Summary of Items Discussed in APSEC Discussion Forum (ADF) 4/2024 on 22 November 2024

2. **Building Separation Requirement – PNAP APP-152**

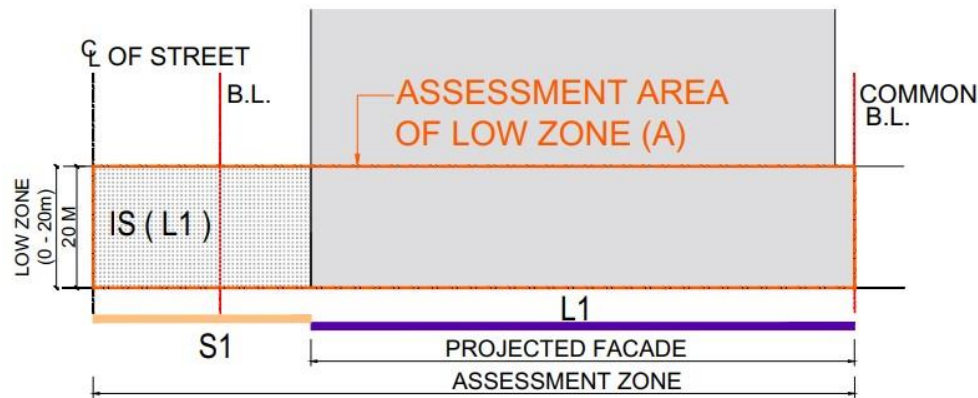
Referring to paragraph 4.2 of Appendix B to PNAP APP-152, not less than $\frac{2}{3}$ of the required permeability (P) shall be provided by intervening space (IS) between the ends of the projected building facades and the adjacent site boundaries or, where the site abuts a *street* or a lane, the centreline of adjoining street or lane, and that such IS shall provide a separating distance

(S) of not less than 7.5 m wide. It is our understanding that if the required S can be sufficiently provided by one end of the projected façade, there is no requirement to provide IS on the other end of the projected façade. Below is a diagram illustrating the described scenario at the low zone, where there is no IS provided on the right-hand side of the building.

Please confirm if our understanding is correct.

LEGEND :
 IS (LOW ZONE)
 $IS (L1)/A \geq 20\%$

BD advised that HKIA’s understanding was incorrect. The provision of separating distance (S) was one of the design requirements for building separation and should be complied with. There should be S of not less than 7.5 m wide between the projected building facades and the site boundaries or the centreline of the adjoining streets or lanes.

Figure B12 of Appendix B of PNAP APP-152 was relevant. This requirement had been in effect since the first issue of PNAP APP-152 in January 2011.

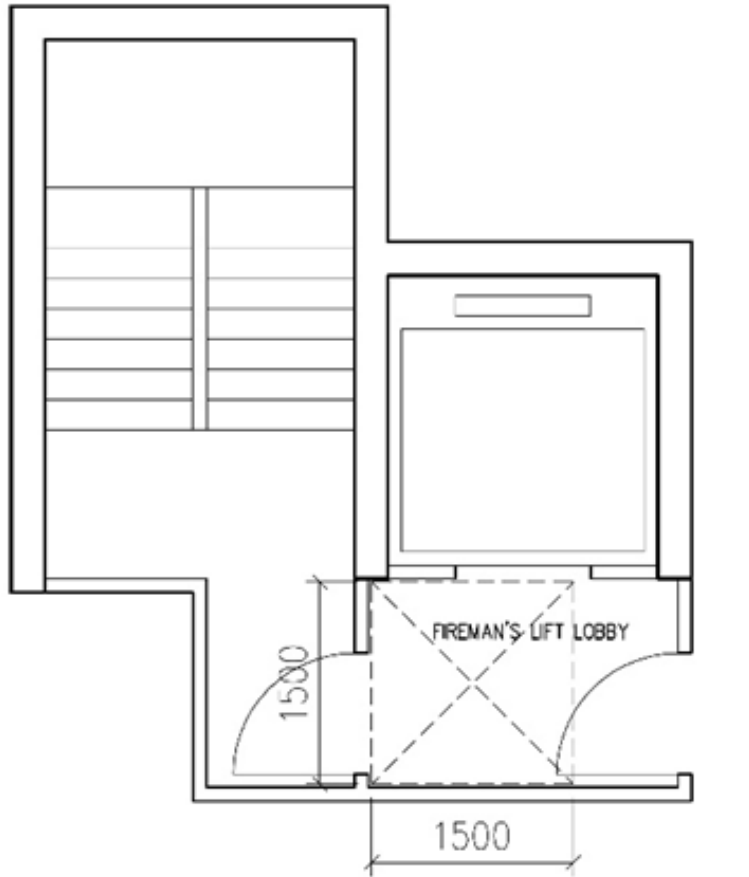
4.	<p><u>Fireman’s Lift Lobby Clear Dimensions</u></p> <p>Clause D11.1 of the Code of Practice for Fire Safety in Buildings (2011) (June 20223 Edition) (FS Code) states that “<i>Each point of discharge from a fireman’s lift to the floor served, except at the fire service access point in Subsection D7, should be through a lobby having a floor area of not less than 2.25 m² and a minimum dimension of 1.5 m</i>”.</p> <p>It is our understanding that the minimum dimension of 1.5 m shall be measured between walls of the Fireman’s Lift Lobby, instead of from the door swing of the lift lobby, as indicated in the diagram below in which the door swing encroaches on the 1.5 m x 1.5m space.</p>	<p>BD advised that the proposed layout was not acceptable as the lobby door in its fully open/end position(s) would obstruct/jeopardize the provision of minimum dimension of 1.5 m in the said lobby.</p>

Please confirm if our understanding is correct.

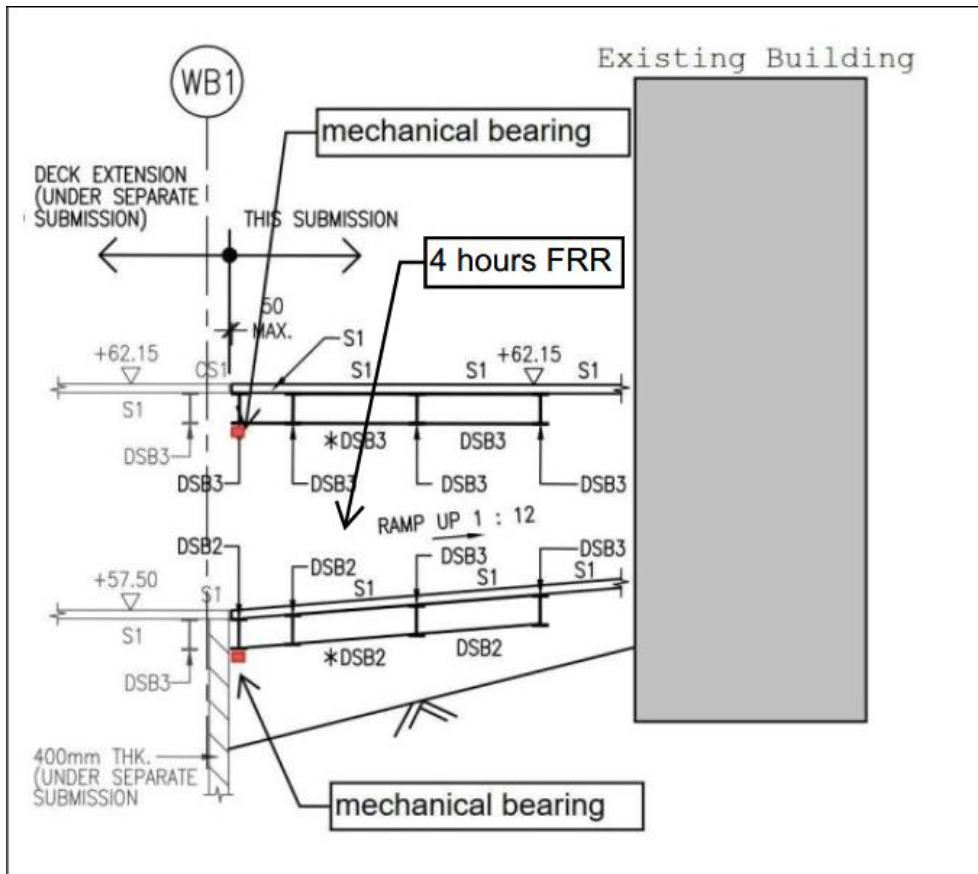
(b) Irrespective of the answer to (a) above, no fire protection is needed for the lower bearing as it is not situated within a compartment.

(b) BD advised that as the lower bearing was not within the fire compartment, no FRR was required.

Figure 2.1 Definition of TCR of the Designated Grade

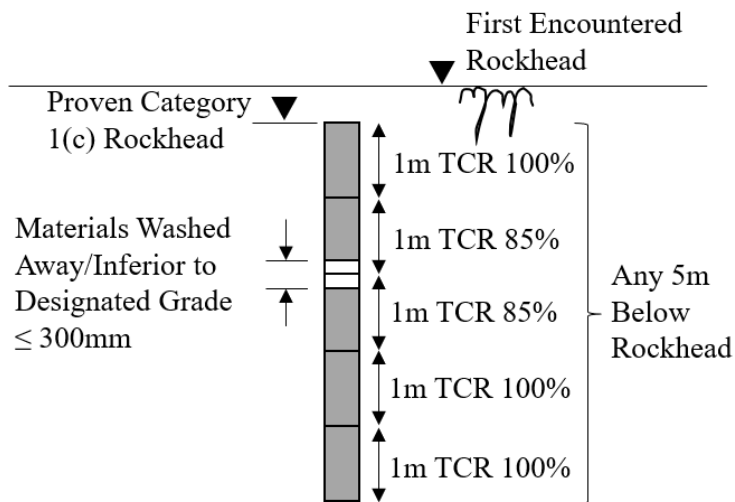
Note 5 under Figure 2.1 of the Foundation Code, which is extracted below, states that “the maximum continuous length of materials washed away/inferior to the designated grade, $b+e$, should not be greater than 300 mm”.

- Notes:
1. TCR of the designated grade = $(a+c+d+f)/L$.
 2. a, c, d and f are materials of the designated grade or better.
 3. b are materials inferior than the designated grade.
 4. e are materials washed away during drilling.
 5. The maximum continuous length of materials washed away/inferior to the designated grade, $b+e$, should not be greater than 300mm
 6. TCR of the designated grade should not be confused with TCR of the core run shown in the site investigation report, which is equal to $(a+b+c+d+f)/L$

For Category 1(c) rock, it is required to have not less than 85% total core recovery (TCR) of the designated grade. This implies that for each 1 m segment, the materials washed away during the coring process/inferior to Category 1(c) rock should not be greater than 150 mm. While the Foundation Code allows any 5 m below the rockhead to be divided into 5 nos.

of 1 m segment for satisfying the requirement that the designated grade and the maximum continuous length of materials washed away/inferior to the designated grade should not be greater than 300 mm, this implies that it is acceptable to have not more than 300 mm materials washed away/inferior to the designated grade right at the junction of the two consecutive segments for Category 1(c) rock (i.e. not less than 85% TCR over 2 m at local spot) as illustrated in the diagram below, instead of applying the examination of rolling 1 m.

Would BD clarify the above interpretation is acceptable and applicable to Category 1(b), 1(c) and 2 rocks?

ACEHK’s interpretation was generally acceptable and applicable to Cat 1(b), 1(c) and 2 rocks with specified values in Table 2.1 except the starting location of 5 m below the rockhead for 5 no. of consecutive 1 m segments. BD clarified that, for defining TCR of the designated grade, the starting location for the 5 no. of consecutive 1 m segments should be taken at that right below the rockhead.

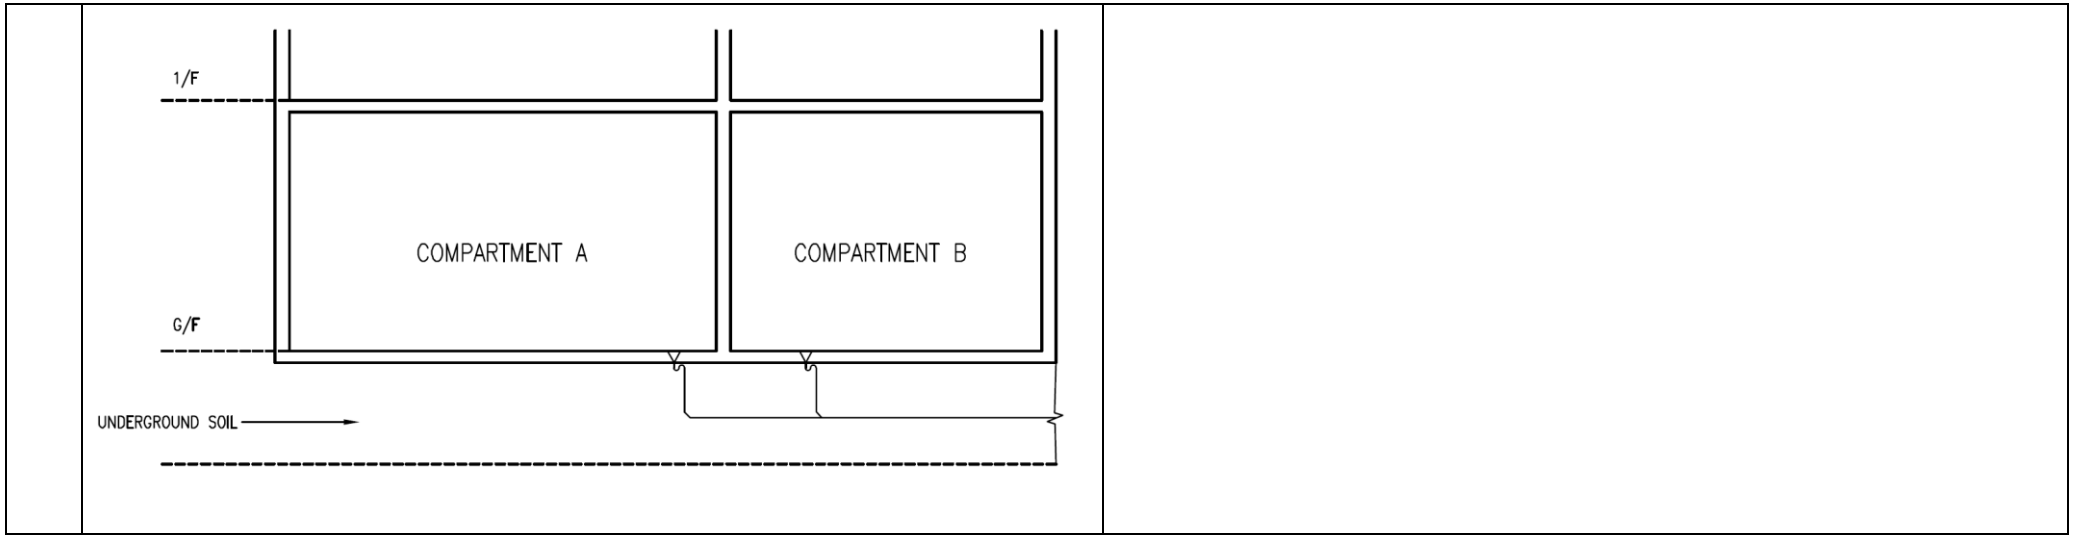
<p>Items raised by PBSCA</p>		
<p>20.</p>	<p><u>Fire Stop for Opening on Ground Floor Slab for Passage of Underground Drainage Pipes</u></p> <p>Referring to the sketch below, since smoke spreads upwards, we opined that the design of the drainage pipe located at the underground passing through two fire compartments would be acceptable without providing fire collars or other forms of fire stop. Would BD please advise if our understanding is correct?</p>	<p>BD advised that where water-borne metallic pipes including drain pipes pass through fire barriers, gaps between the pipes and the fire barriers should be properly filled by fire rated material having an FRR of not less than that of the fire barrier that it penetrates according to Clause C8.6 of the FS Code. PBSCA was encouraged to provide further information of the case for separate discussion with BD.</p>
